P5020A-03A-S

Safety Service Note

P5020A Keysight Streamline USB Vector Network Analyzer

“POTENTIAL BURN INJURY (HIGH TEMPERATURE) HAZARD”

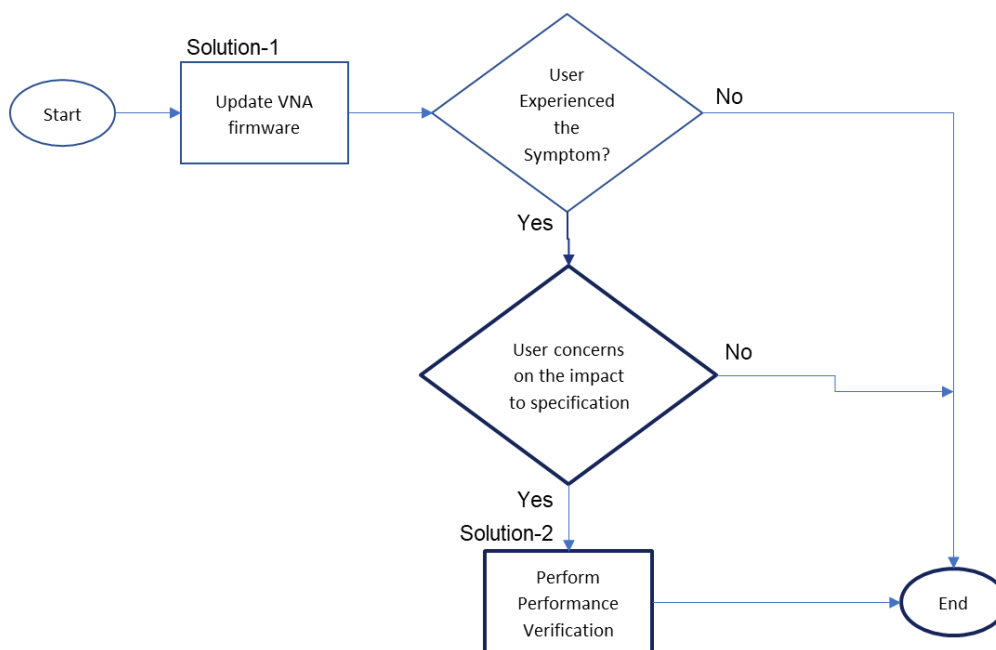
VNA fails to start with the following symptoms.

1. LED indicator (below circle) turns red.
2. cooling fan does not work
3. If user leaves the VNA with this LED indicator red without turning off power switch, it continues to overheat and becomes too hot.

Solution-1: Update VNA firmware by user

Solution-2: Perform Performance Verification by Keysight

1. **Install the latest VNA firmware Rev. A.15.55.14 or newer** on users' controller PC(s).
The latest firmware enhanced the thermal fan control mechanism.
2. Once the latest firmware is installed, proceed with the restart of both **controller PC** and **VNA**.
3. Launch the VNA firmware. Ensure VNA powers up and launches into firmware correctly after firmware update is done.
